RE: Final Soil Vapor Extraction System Effectiveness Zone 6 Optimization Report, Hartford
Petroleum Release Site, Hartford, Illinois

USEPA COMMENTS DATED AUGUST 2, 2016 AND APEX OIL COMPANY, INC. RESPONSE DATED AUGUST 26, 2016

Apex Oil Company, Inc. Response to USEPA Comments
Draft Soil Vapor Extraction System Effectiveness Zone 6 Optimization Report
Hartford Petroleum Release Site, Hartford, Illinois

TITLE: FIGURE 7. GENERALIZED STRATIGRAPHIC AND
DETAILED LITHOLOGIC INTERPRETATIONS ALONG
NORTH OLIVE AVENUE

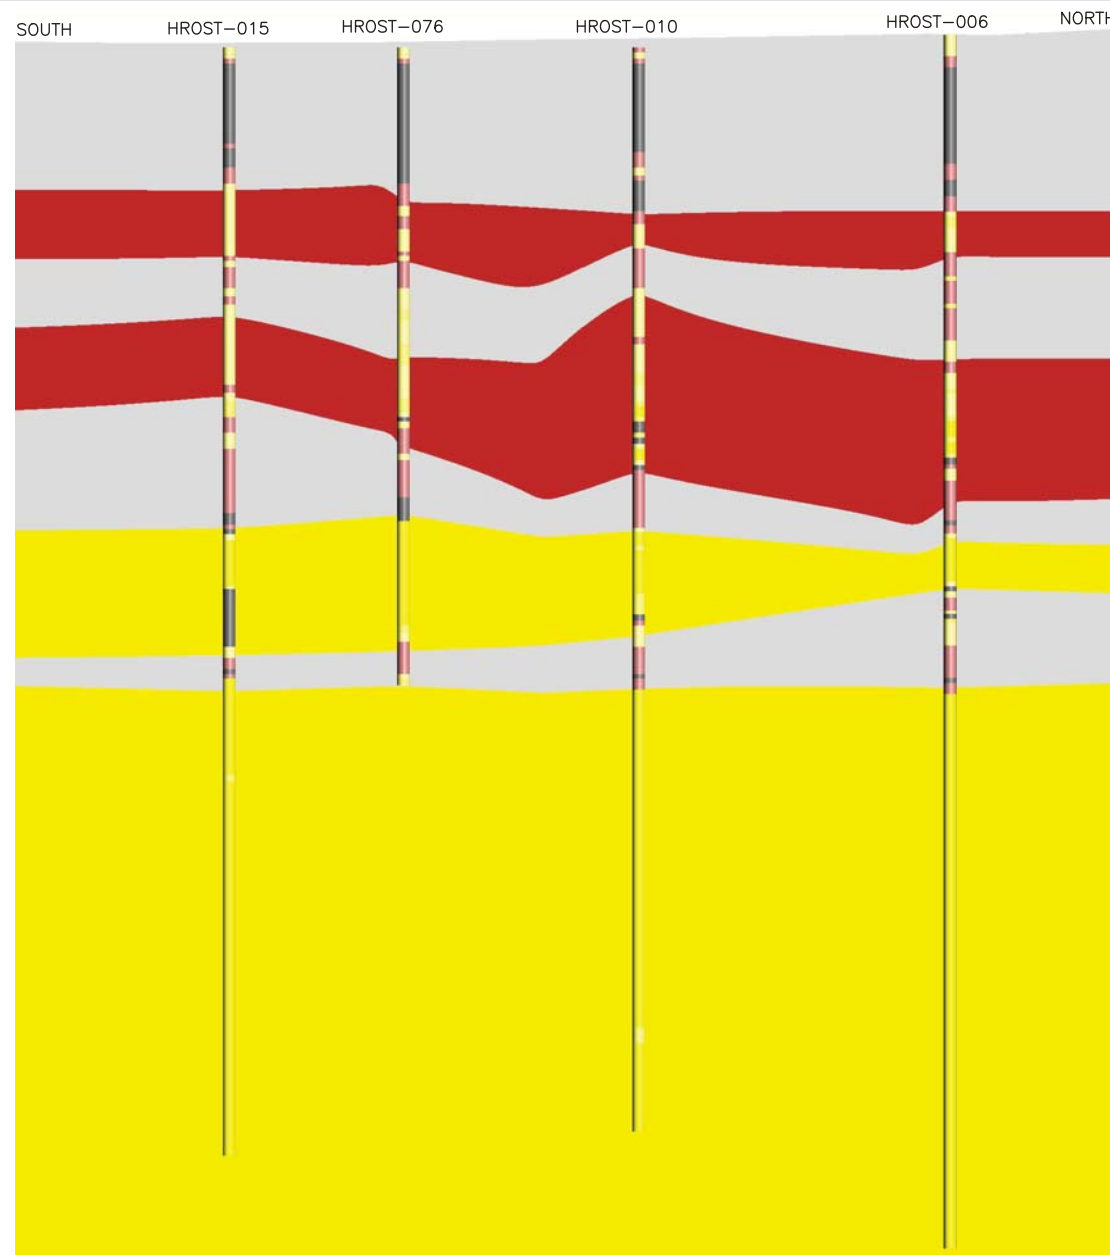
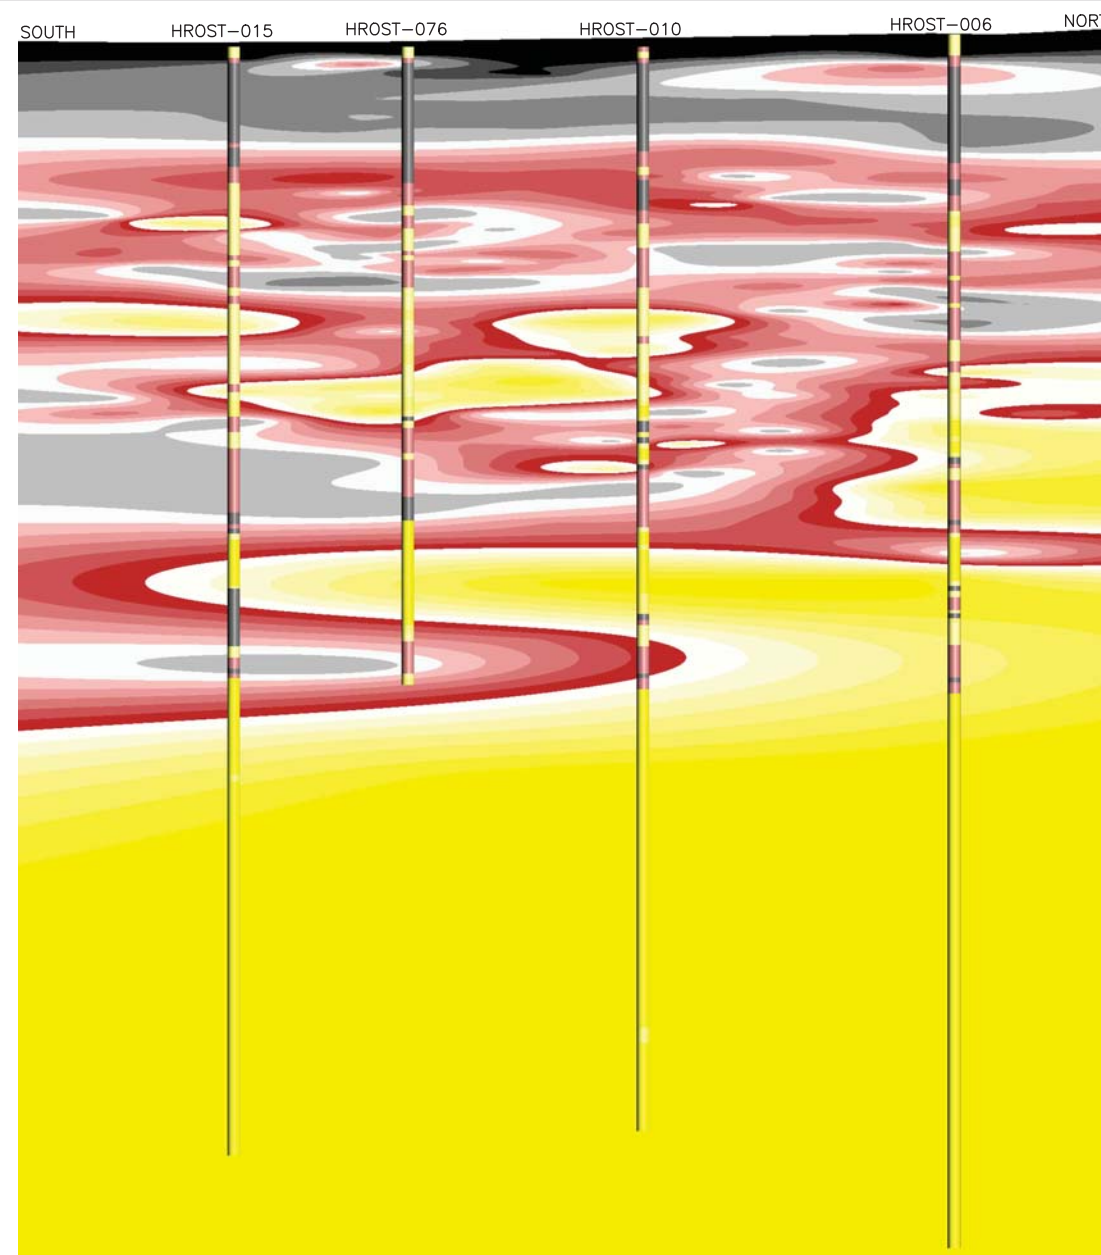
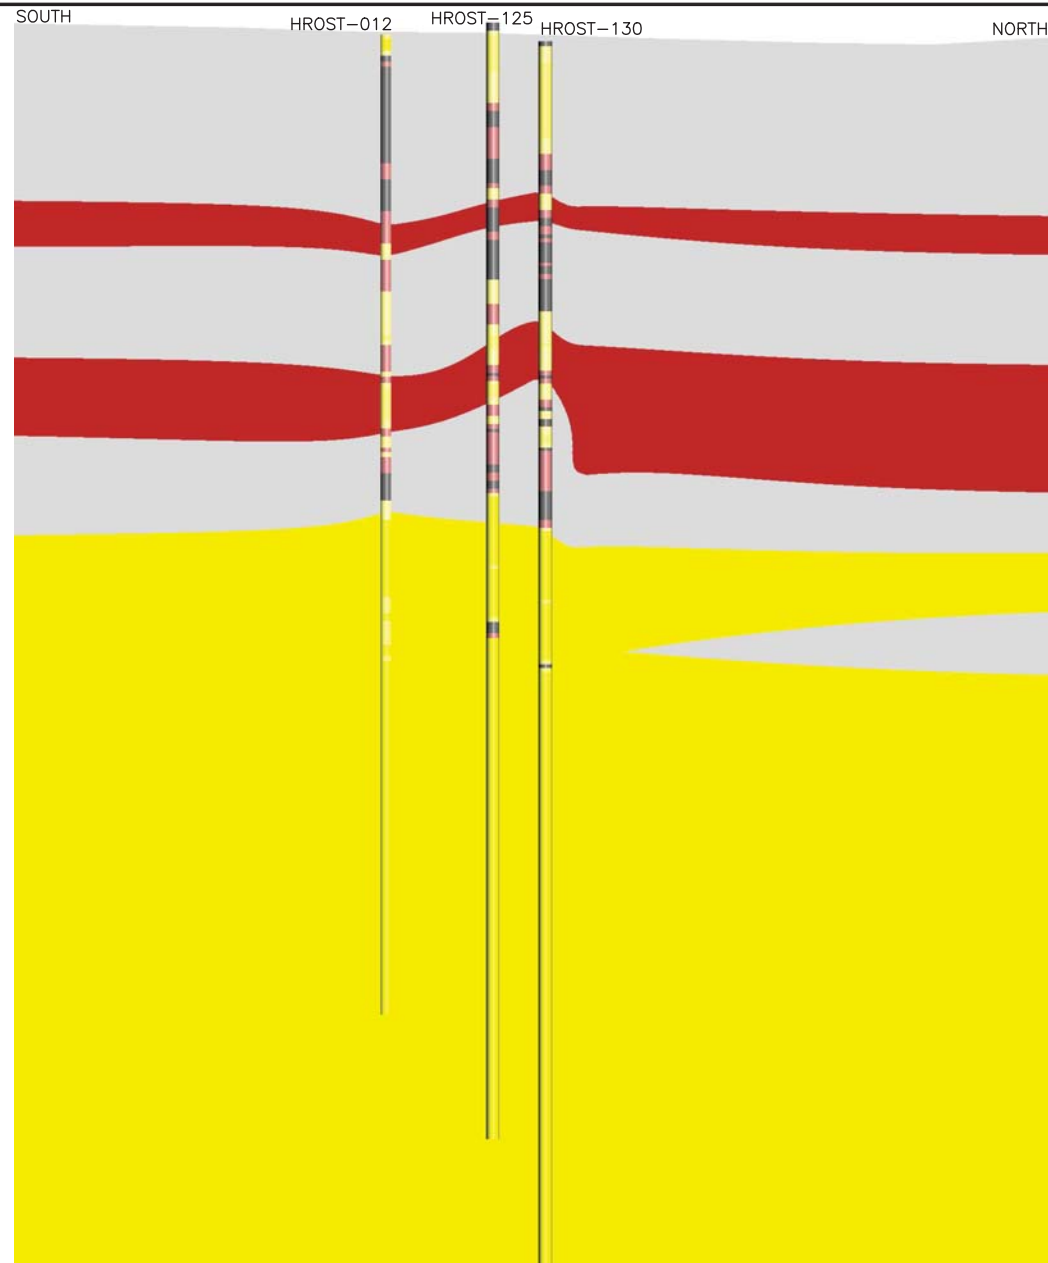
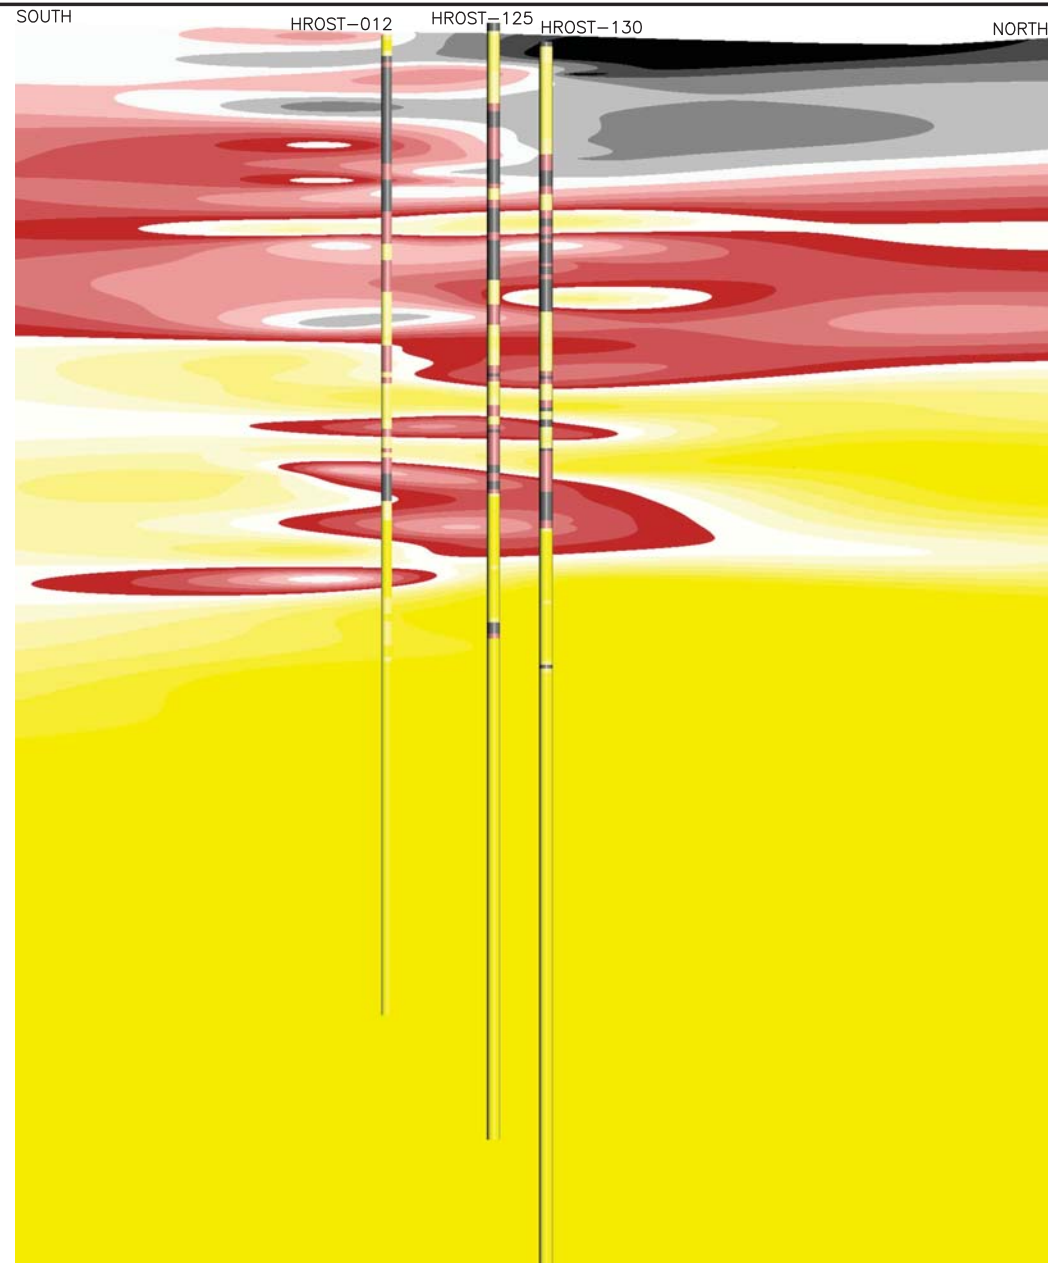
| Comment Number | Sub-section | Topics of Discussion | Recommended Revisions |
|--------------------------|--|--|---|
| 6 | 3.1.2 Detailed Lithologic Interpretation Page 3-5 Figures 7 and 8 | Re: “ <i>While the detailed lithologic interpretation depicts a more nuanced and discontinuous setting within the upper 40 feet of the subsurface compared to the generalized stratigraphic interpretation, it is not any more accurate in showing the actual geology, as reported within the borings installed via Cone Penetration Testing .</i> ” | Use of Cone Penetrometer Testing data may be beneficial in the future, but should not wholly replace 3DVA of “actual geology” based on USCS Soil Types data. Further, if 3DVA of detailed lithology using numeric value equivalents to represent USCS Soil Types is to be continued, it is recommended that these data equivalents be used to visualize the heterogeneity based on “actual geology” versus emulating the approach of representing geology expressed as the distribution of relative hydraulic conductivity (K _R). The K _R approach, however, may provide greater benefit in the future when remediation is more specifically focused on the distribution, fate and transport of dissolved phase contamination. |

| Comment Number | Sub-section | Topics of Discussion | Recommended Revisions |
|--|---|---|--|
| Response to Comment 6 | Apex concurs that the use of cone penetrometer testing (CPT) data, or similar geophysical data (e.g., electrical conductivity) could be useful to resolve specific data gaps related to the Hartford Site. Apex also agrees that such geophysical data does not replace the use of 3D visualization of the lithologic setting. As discussed in Section 3.1.2 and further described in Appendix A, the USCS soil types were converted to a numerical value based on relative grain size and sorting with the soil types comprised of the smallest grain size (i.e., high plasticity clays, fat clays) assigned a value of 1 and largest grain size (i.e., well graded sands or gravelly sands) assigned a value of 16. During the teleconference between 212 Environmental Consulting, LLC, United States Environmental Protection Agency (USEPA), and Titrates conducted on April 13, 2016, it was agreed that a whole number numeric value would be used to depict the USCS soil types within the revised 3D visualization of the lithology underlying Zone 6. It is likely that the numeric value equivalents used in the revised 3D visualization of the lithology underlying Zone 6 would be consistent with a reinterpretation of the 3D visualization of lithology performed using a distribution of relative hydraulic conductivities for each UCSC Soil Type. It should be noted that the hydraulic conductivity for a given UCSC Soil Type can span several orders of magnitude (http://www.geotechdata.info/parameter/permeability.html). | | |

| TITLE: FIGURE 9. 3D VISUALIZATIONS OF GENERALIZED STRATIGRAPHIC AND DETAILED LITHOLOGIC INTERPRETATIONS | | NO SCALE <small>SCALE.</small> | 16-001-07 <small>PROJECT NO.</small> | 06/20/16 <small>DATE.</small> |  <div>816 Delta Avenue Cincinnati, Ohio 45226 (513) 430-1766</div> |

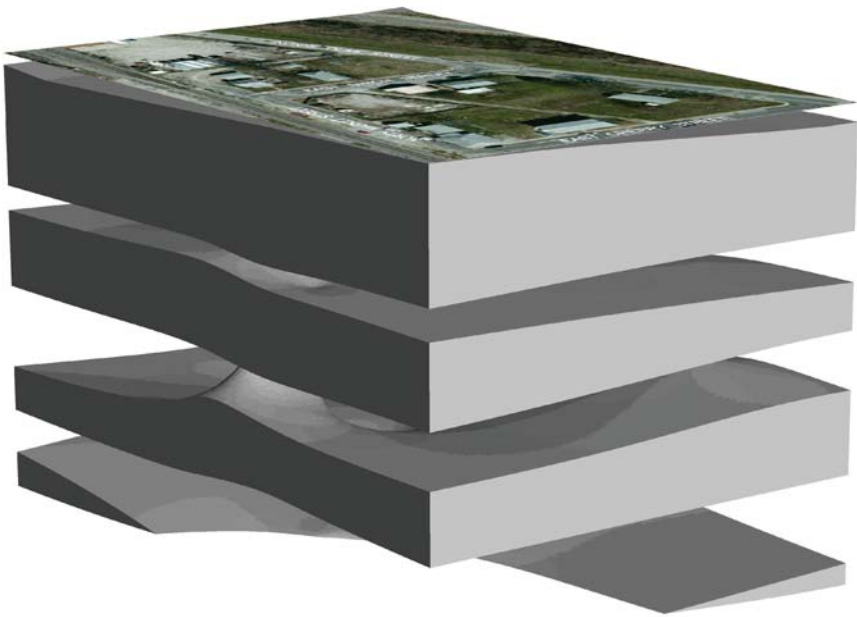
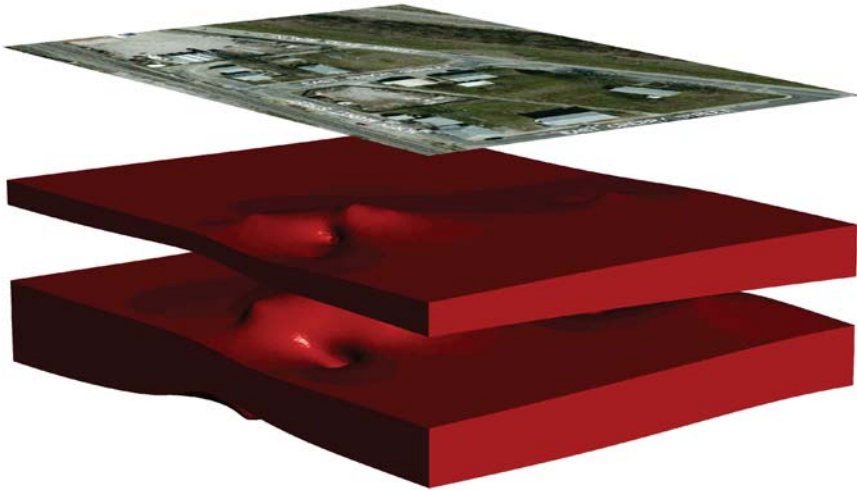
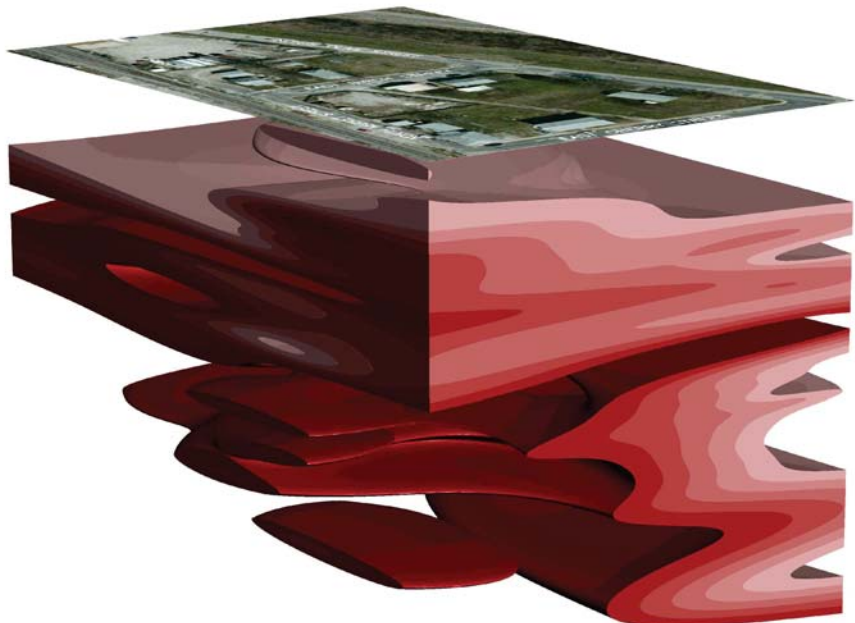
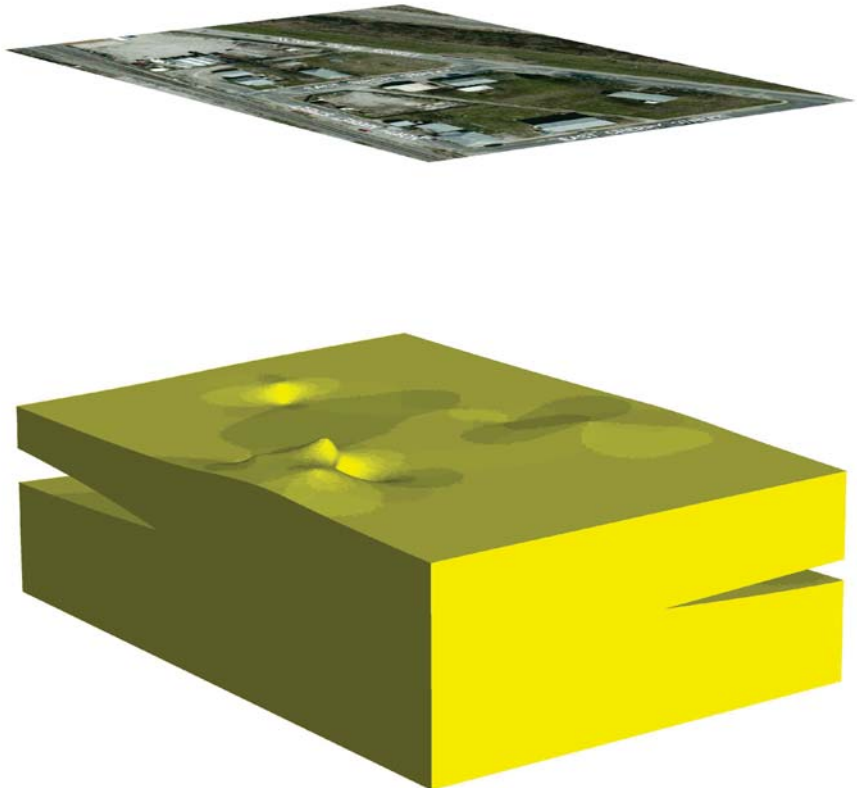
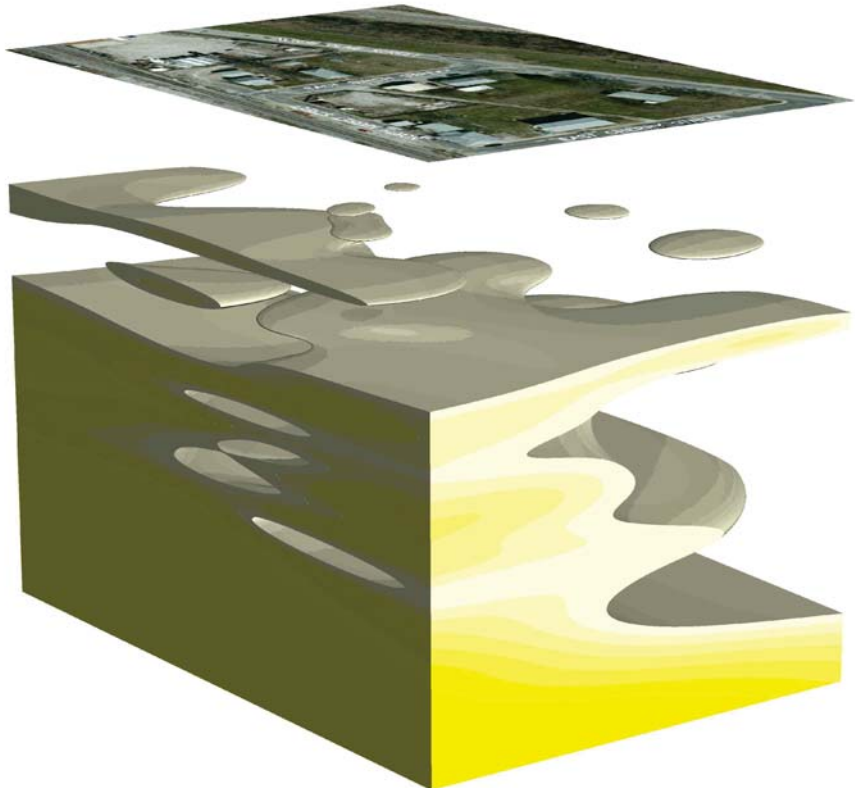
| Comment Number | Sub-section | Topics of Discussion | Recommended Revisions |
|--------------------------|--|--|---|
| 5 | 3.1.1 Generalized Stratigraphic Interpretation Page 3-3 Figure 9 | Re: “ <i>In addition, a 3D isopach map of the generalized stratigraphy showing the clay, silt, and sand units is included on Figure 9.</i> ” | It is recommended that these 3DVA approaches and outputs continue to be used to evaluate the site and to communicate site conditions to stakeholders, as specified in Comment Numbers 6 and 7. Given the current condition of the site, it may provide additional benefit in the future to apply integrated 3DVA (geology, hydrogeology and contamination [all phases as applicable]) at the strategic and larger-scale evaluation levels as the remedy progresses, and to present the results using this approach to lithologic visualization. |

| Comment Number | Sub-section | Topics of Discussion | Recommended Revisions |
|--------------------------|--|--|---|
| Response to Comment 5 | Please refer to the Response to Comment No. 2. | | |
